Development Control Committee 27 June 2012
Item 14 - Land at Bridge Farm, Ivel Road, Shefford, Ref 12/01125

Shefford: Applications Ref CB/12/01125/FULL and CB/12/01123/OUT

CB/12/01125/FUL and CB/12/01123/OUTLINE, Bridge Farm, Ivel Road, Shefford

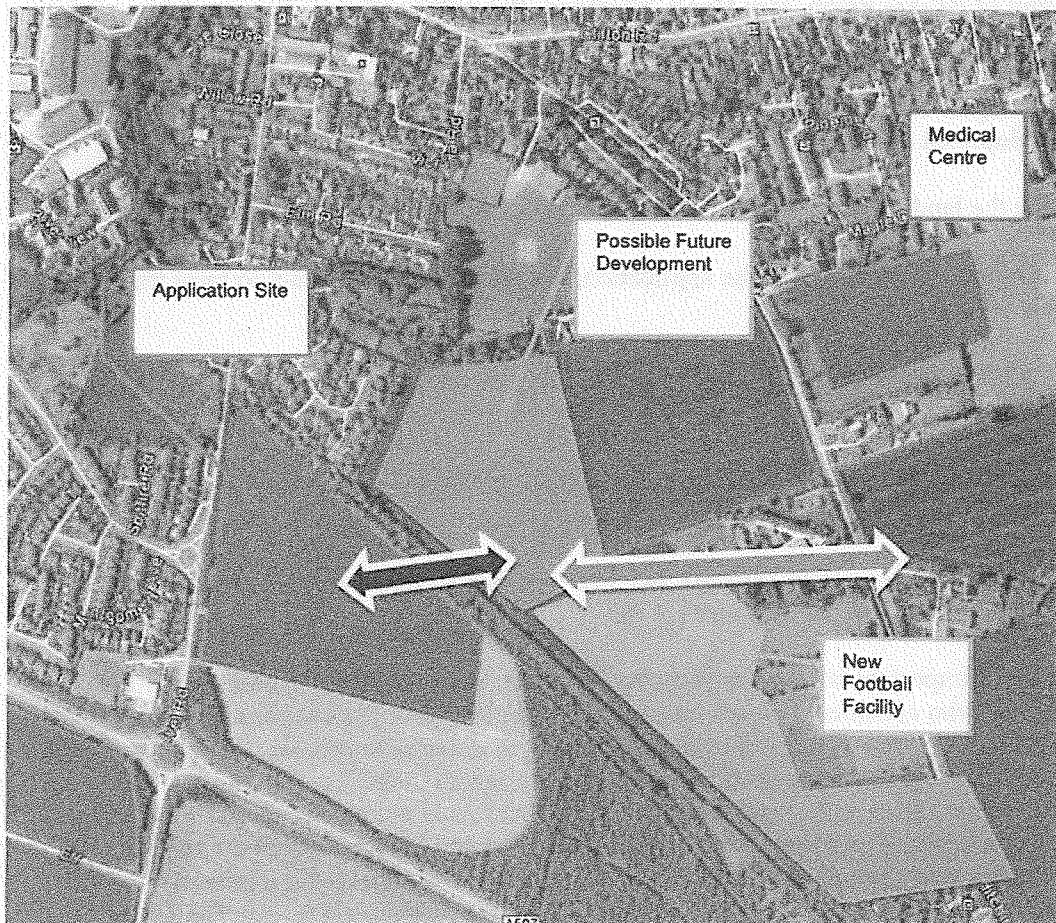
To provide some context to this matter, should our clients land ever come forward for development it is likely to accommodate 150 – 200 houses (shown orange below) and its main access would be taken from a partially implemented roundabout access off Hitchin Road to the east. (Purple arrow) This access has been recently constructed in compliance with the necessary standards to provide access to the new Shefford Football facility. (Green) 300 children will utilise this facility. As you may also be aware Shefford Medical Centre opened on Hitchin Road in 2011 and is a key destination within the settlement. (Light Blue) Finally, Samuel Whitbread Community College have plans to provide a new access from Hitchin Road to assist in removing coach traffic from the existing frontage in Shefford Road.

Therefore we consider it very likely that should any link be provided in the future from the site to our clients land (Black Arrow) it will quickly become a desirable route for residents coming from the west of the town via Old Bridgeway and Churchill Way seeking to access the Medical Centre, Football facility, potentially the school or simply just avoid the congestion within Ivel Road, High Street and on Clifton Road.

It is our submission that the proposed link should be increased in width to 6.25 metres such that it would accord with Central Bedfordshire standards and recently adopted policy for a link of this nature.

1. Require a minimum link road width of 6.25 metres: and
2. Require the safeguarded route to be adopted up to the eastern boundary
